COMMUNITY DEVELOPMENT DEPARTMENT REPORT

HEARING 11/6/2025
DATE: *Vacated from 3/20/2025 agenda;
continued from 10/2/25*
TO: Planning & Zoning Commission
FROM: Sonya Allen, Associate Planner
208-884-5533
sallen@meridiancity.org
APPLICANT: Brighton Corporation
SUBJECT: H-2024-0061
Apex Cadence (aka Pinnacle) – ALT,
MDA, PUD, PP, RZ, PS
LOCATION: 6575 S. Locust Grove Rd., in the NE 1/4
of Section 6, T.2N., R.1E. (Parcel
#S1406110355 & a portion of
#S1406110016)

D. Proposed Conceptual Development Plan – NOT APPROVED

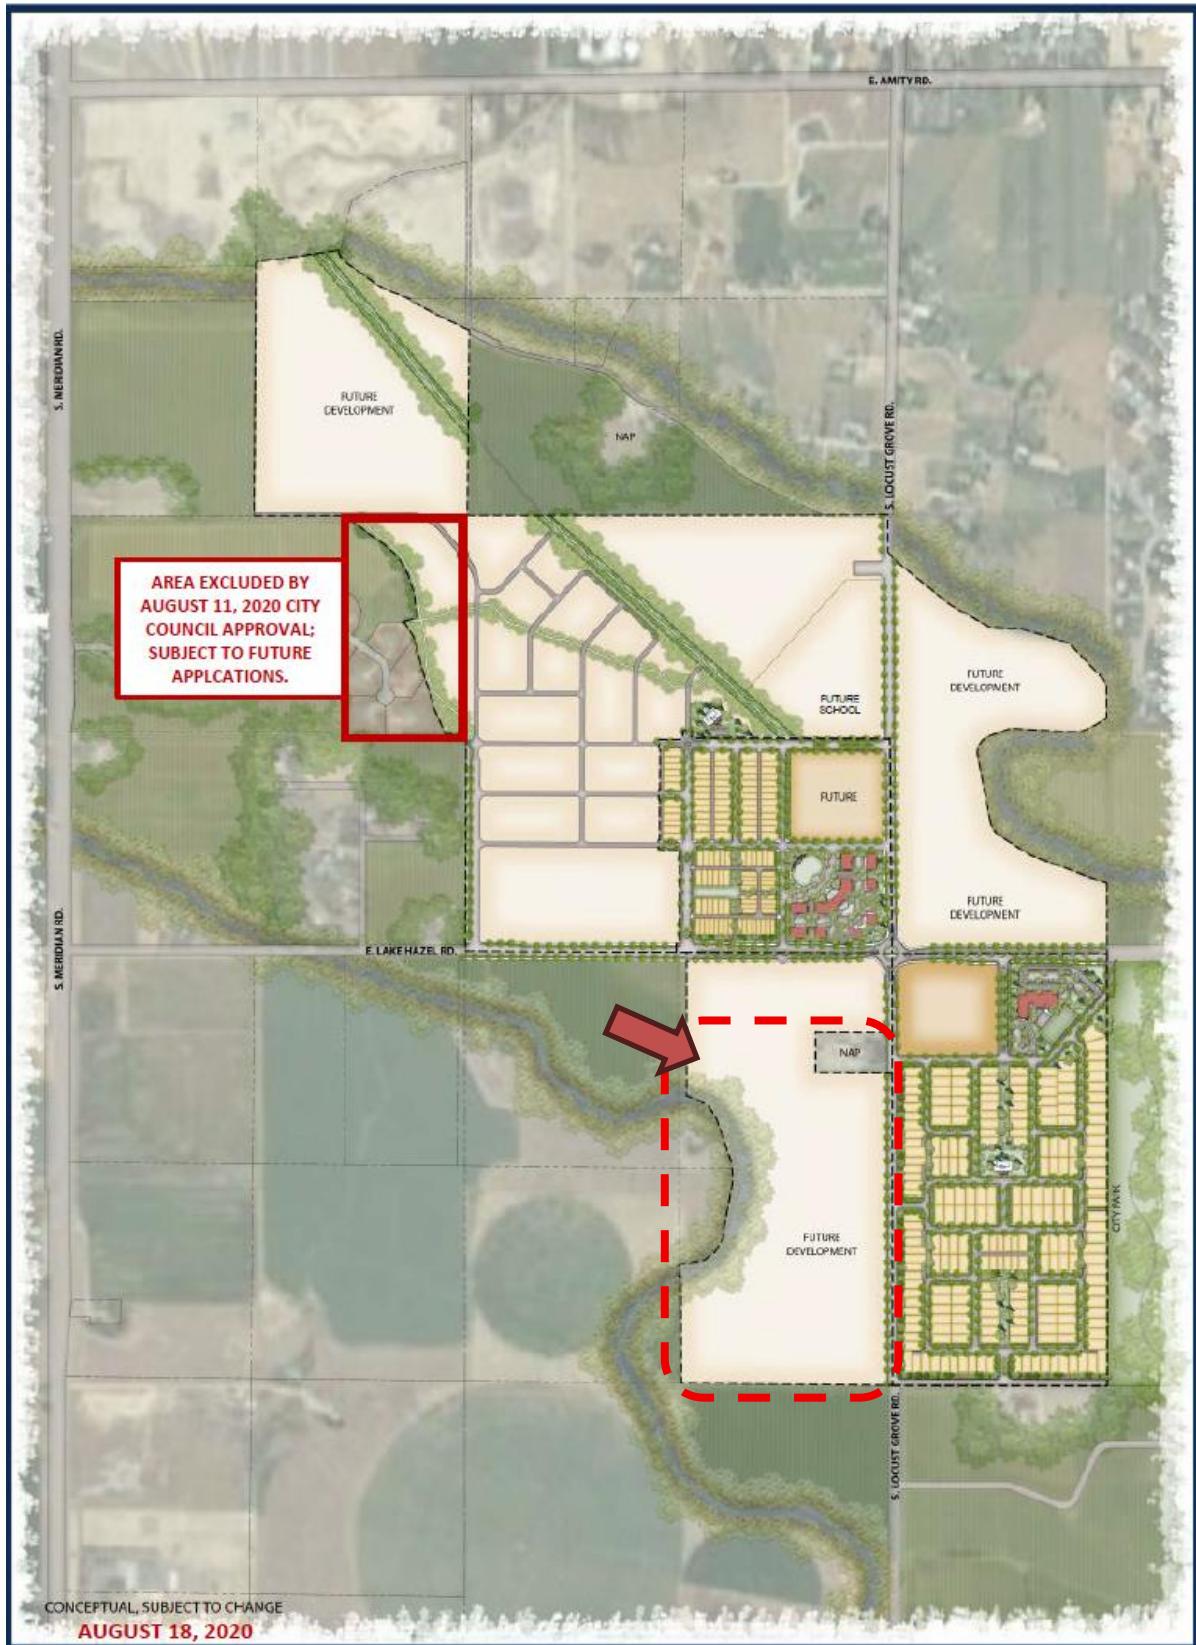
Future collector streets are depicted on ACHD's Master Street Map on the property to the north of the proposed subdivision. The concept plan included in the Applicant's narrative and phasing plan doesn't accurately depict the location of the extension of S. Apex Ave. from E. Lake Hazel Rd. on the property to the north and doesn't depict the extension of the collector to the east in alignment with E. Tower St. and therefore, isn't approved. **Staff recommends as a provision of the development agreement that these collector streets, or a portion thereof as applicable, are included in a future subdivision of the property to the north. Said collector streets should align with S. Apex Ave. on the north side of E. Lake Hazel Rd. and E. Tower St. on the east side of S. Locust Grove Rd. The concept plan should be revised accordingly prior to the City Council hearing.**
